Colossal Cave Road Improvement Project: Acacia Elementary School to Old Vail Road

Final Addendum to Environmental Assessment And Mitigation Report

September 2008

**FINAL ADDENDUM TO
ENVIRONMENTAL ASSESSMENT
AND MITIGATION REPORT**

FIGURE 1

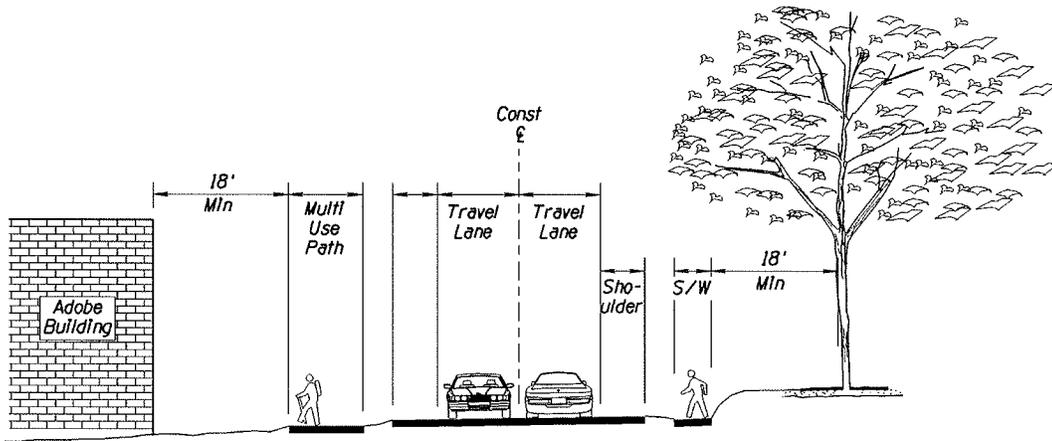
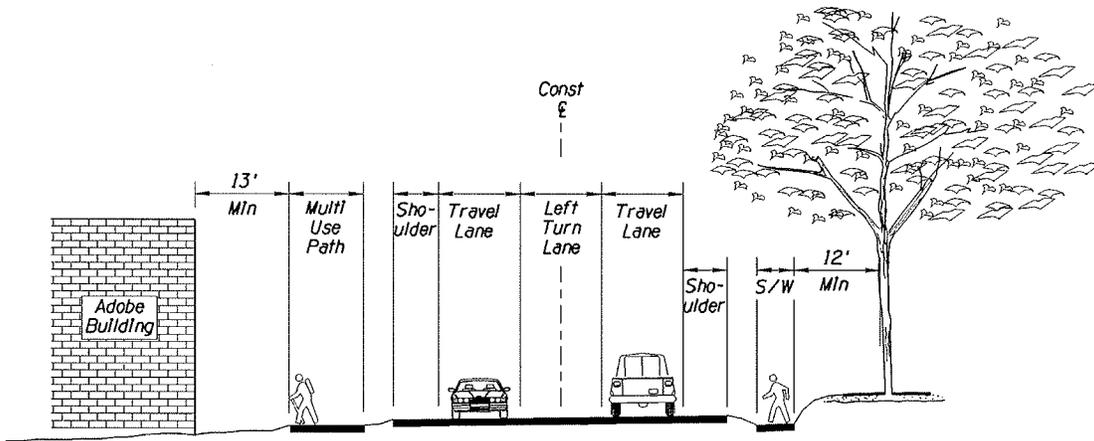
Therefore, Pima County staff made the decision to leave the centerline in its originally planned location and widen the roadway an equal distance on each side to obtain the additional width required for the three-lane cross section. Figure 1 shows the changes made in the cross section to accommodate a three-lane roadway and compares them to the previously proposed cross section for a two lane roadway. Note that on the west side, the nearest edge of the pedestrian facility is 13 feet from the face of the adobe building with the three-lane section compared to 18 feet with the two-lane roadway. On the east side, with the three-lane roadway the nearest edge of the pedestrian facility is 12 feet from the line of trees whereas with the two-lane roadway it was 17 feet away.

- Shrine of Santa Rita: The roadway and adjacent pedestrian facility will be 5.5 feet closer to the front of the property. Since the historic shrine building sits back a considerable distance from the roadway, the building itself has never been impacted by any of the alignments considered or the options regarding number of lanes. The potential impact is on the trees and fence along the front of the property. With the centered three-lane alignment now being proposed, the fence and line of trees would not have to be relocated or moved. However, some of the trees may have to be trimmed to prevent trucks from hitting their branches.
- Adobe building (the old Vail Post Office): The roadway and adjacent pedestrian facility will be 5.5 feet closer to the adobe building. Therefore, the previous determination to limit vibratory
